#### UNITED STATES NUCLEAR REGULATORY COMMISSION WASHINGTON, D. C. 20555

MAY 2 9 1980

### DISCUSSION PAPER

Some Thermodynamic Considerations Regarding Zirconium-Water Reactions

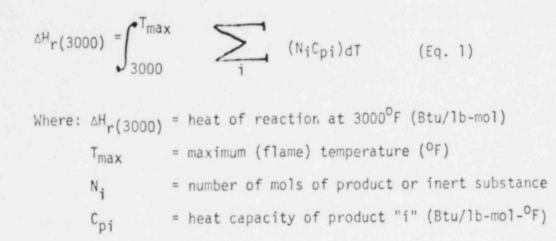
In your letter to Commissioner Hendrie, dated April 2, 1980, you stated that Figure 4 of SECY-20-107 was erroneous. The basis for this opinion was your belief that the thermodynamics of the Zircaloy-steam reaction were ignored. In a follow-up telephone discussion with a member of our staff, you stated that, specifically, the peak cladding temperature as displayed in Figure 4 was probably too high. Also, in your letter, you requested that the staff provide you with certain calculations of maximum flame temperature for the zirconium-oxygen and zirconium-water reactions.

reaction. These are the thermal proximity of the UO<sub>2</sub> and Zircaloy and the contribution of the decay heat source. These factors are examined below with the aid of the attached Figure 1. The upper cladding temperature curve is identical to the calculation shown in SECY-80-107. The lower curve is the same calculation but without any zirconium-steam reaction. In the first calculation the reaction was complete at 406 seconds and the maximum cladding temperature was 6490°F. At 406 seconds in the second case the cladding temperature was 3000°F. Since both cases started at the same temperature (223°F) and had the same decay heat, the temperature contribution from decay heat in both cases was 2767°F. The reaction heat contribution to the maximum temperature was 3490°F (see Figure 1).

Within 10 seconds after completion of the reaction in Case 1, the cladding temperature drops to virtual thermal equilibrium with the fuel. From this time onward the cladding and fuel temperature were within 10°F of each other.

Cases 1 and 2 are tabulations of the TØØDEE2 results shown in Figure 1. Case 1, of course, is the actual cladding temperature, whereas Case 2 is the average of the fuel and cladding temperatures. This would be the condition if fuel and cladding were in thermal equilibrium. The degree to which Case 1 departs from equilibrium will be explained shortly.
